Comments on the interim report of the Review Study on Circulators

December 2016

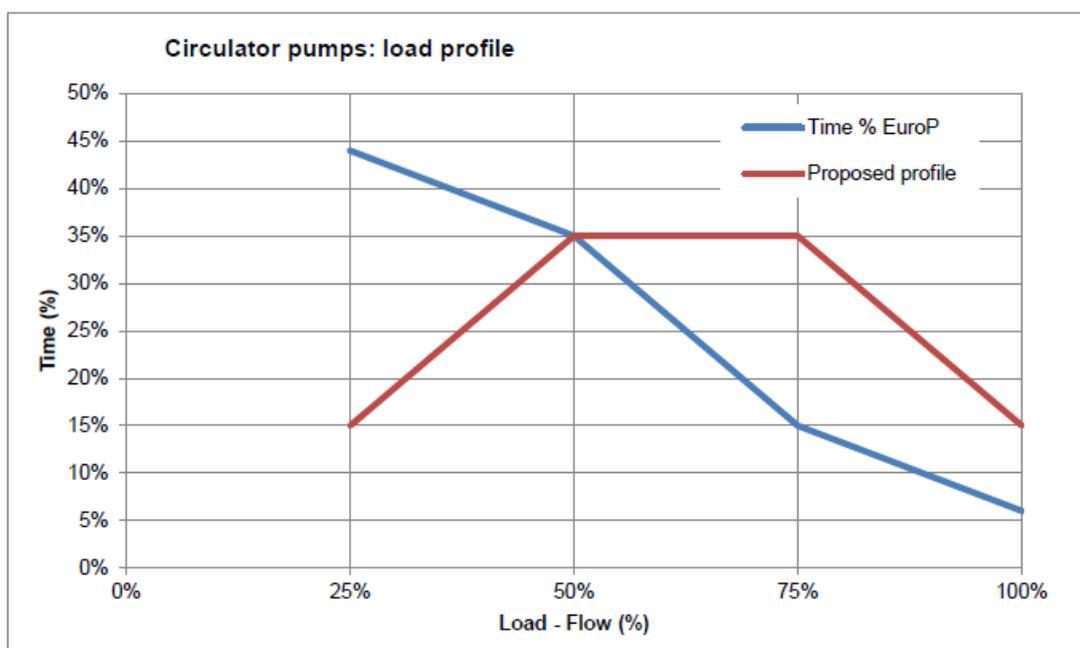
- If installation costs are the same irrespective of efficiency levels, then they do not impact LCC calculations and are of little importance for the study conclusions. It is unnecessary to suggest precise installation costs, as this could become controversial. Solely mentioning a range would be sufficient for the report.
- The flow-time profile (p. 18) dates from 2003 and is most likely not representative of today's products and the trends towards more appropriate sizes and better installations. There may be more time spent at the 75% flow-rate point. A suggestion for a more realistic profile is provided below:
